# Passive House Feasibility Study

366 Broadway Residences, Somerville, MA

August 30, 2022

366 Broadway, Somerville, MA

### 1. Baseline WUFI Model with (0.31 cfm/ft<sup>2</sup>) Airtightness

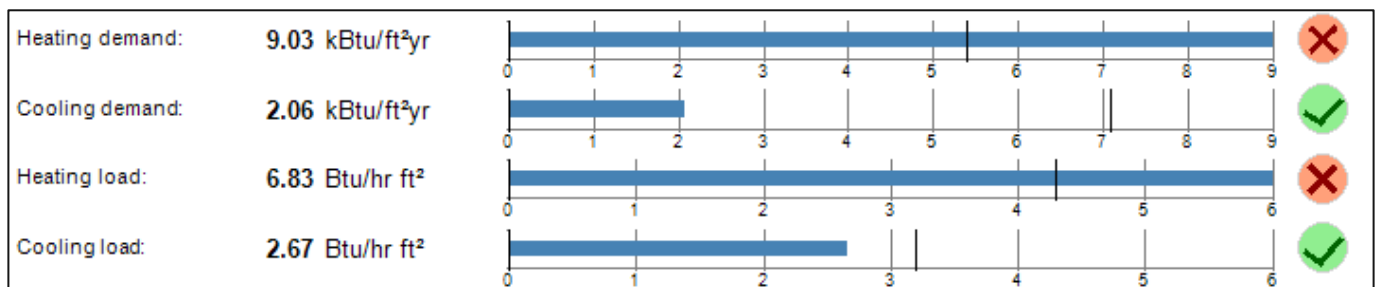
The initial baseline case shows the building fails to meet the heating demand and heating load thresholds due to the lower airtightness and lack of insulation. The reason cooling demand and load is easily met is due to higher air leakage and the northeastern climate.

### 2. Baseline WUFI Model with (0.06 cfm/ft<sup>2</sup>) Airtightness

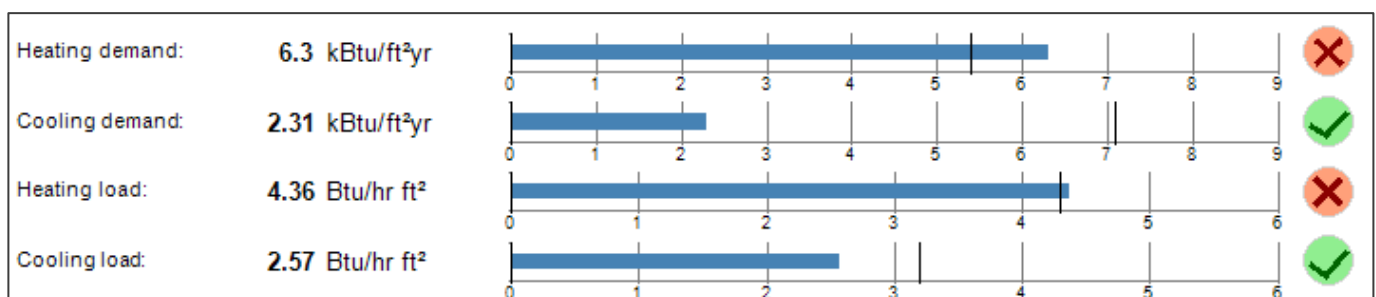
These results show improvements from the baseline design simply by increasing the building airtightness from 0.31 cfm/ft<sup>2</sup> to 0.06 cfm/ft<sup>2</sup>. Heating demand and heating load results are reduced significantly but are still above PHIUS CORE 2021 targets.

### 3. PHIUS 2021 WUFI Model with (0.06 cfm/ft²):

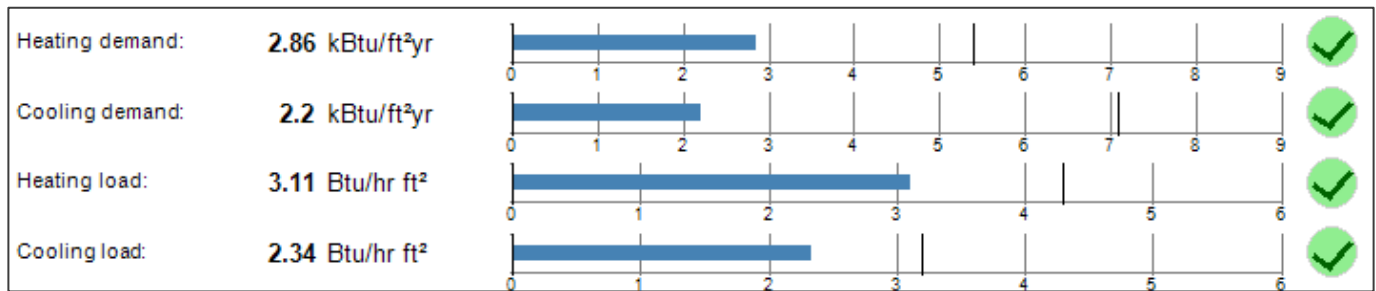
In order to meet the PHIUS requirements, the design would need to make adjustments to the building envelope and select high efficiency equipment for heating/cooling, ventilation and DHW.

Example A:

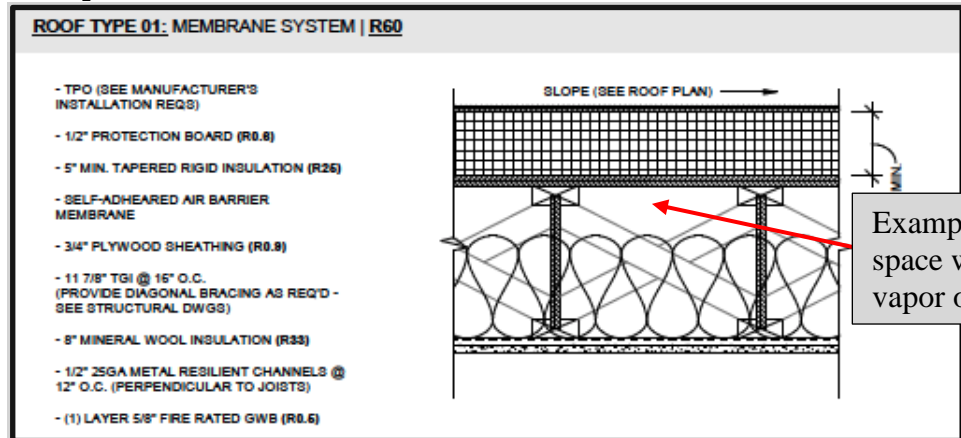
If vapor open insulation is used below the roof deck, there must be no open airspace between the roof deck and the interior insulation (see Example A image below), or a vapor closed insulation (closed cell foam) should be used.

Example: Fill this entire space with insulation if using vapor open insulation.

In the case of insulation above and below the roof deck, our recommendation for reducing condensation potential is one of the following options:

1. Fill entire space below roof deck with blown-in insulation.

2. Use closed cell spray foam to fill the space below the roof deck equivalent to an R-40 or better (dependent on thickness of exterior foam).

# Exterior Walls

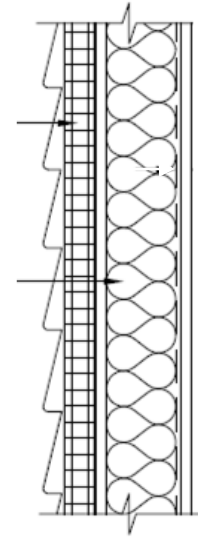
Baseline: R-25     PHIUS: R-37

3" Roxul Cavity  
Rock  
continuous  
insulation

5.5" of cellulose  
cavity insulation

# Roof Assembly

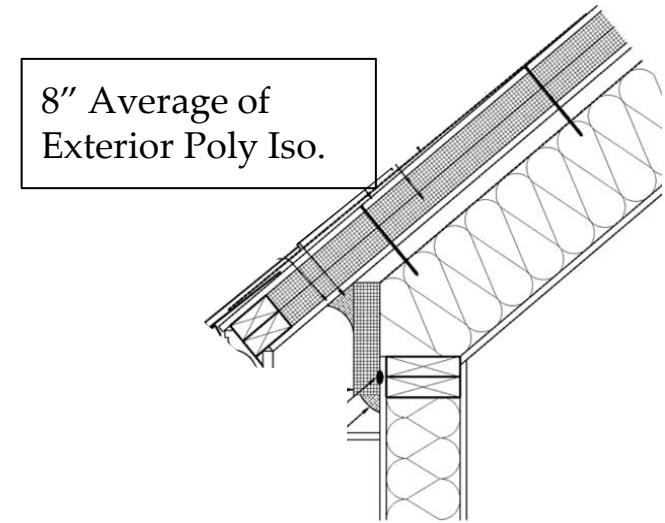
Baseline: R-31   PHIUS: R-50

# Foundation

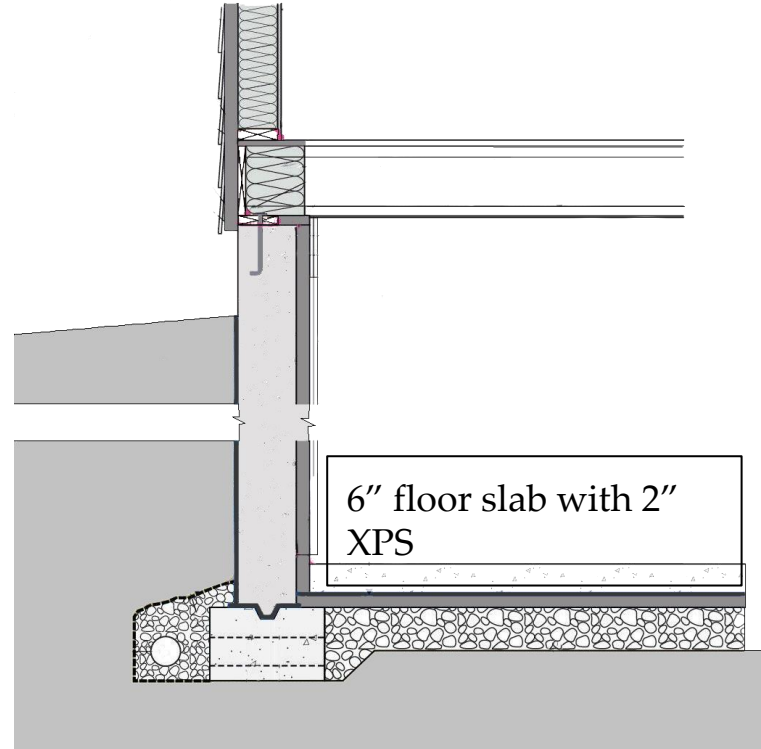
Baseline: R- 10    PHIUS: R- 11
